CITY OF ALBUQUERQUE

RE: **Lot 18 Block 7, Volcano Cliffs, Unit 18, SAD 228**
6623 Sujeto Rd. NW
Grading and Drainage Plan
Engineers Stamp Date 12/7/19 (D10D003M39)

Based upon the information provided in your submittal received 12/9/19, this plan is approved for Grading Permit.

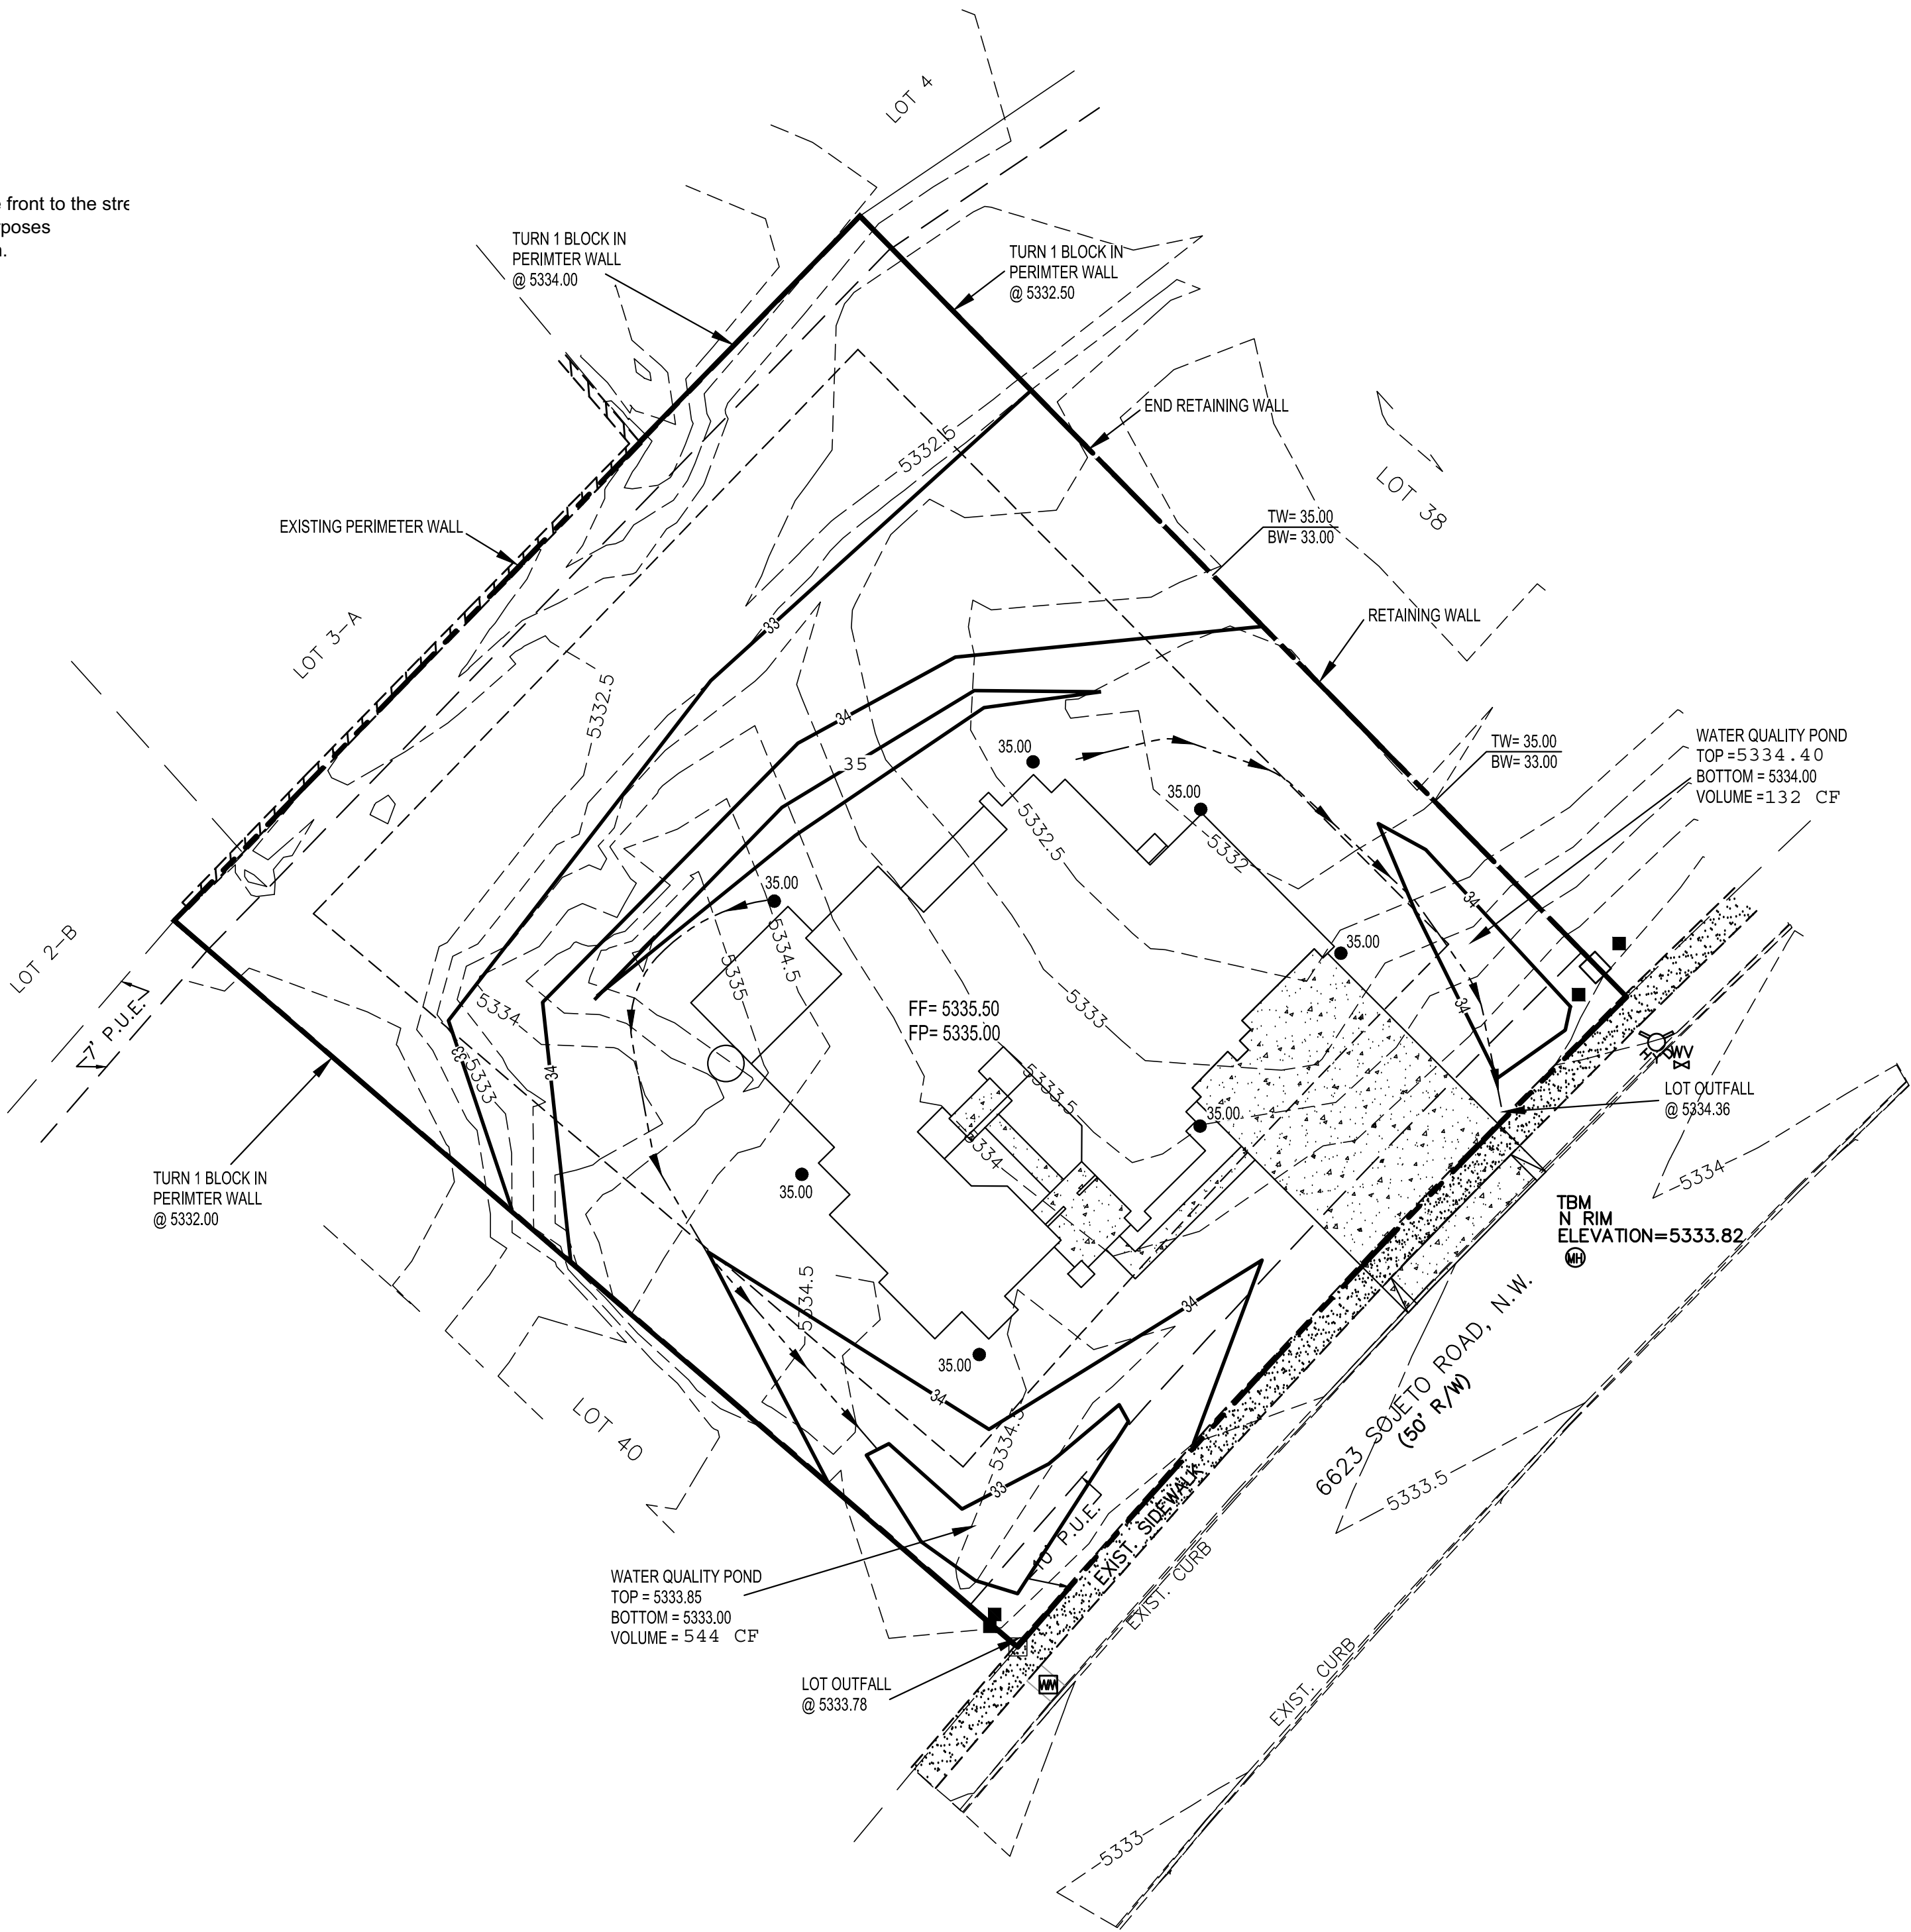
Prior to Building permit approval a Pad Certification will be required, provided by the Engineer or a registered Land Surveyor.

Reiterate to the Owner/Contractor that a separate permit for a garden/retaining wall must be obtained with the approved G&D plan and Pad Certification. Also, if a swimming pool is to be placed the grading and drainage plan will change and will need to be resubmitted.

Prior to Certificate of Occupancy release, Engineer Certification per the DPM checklist is required.
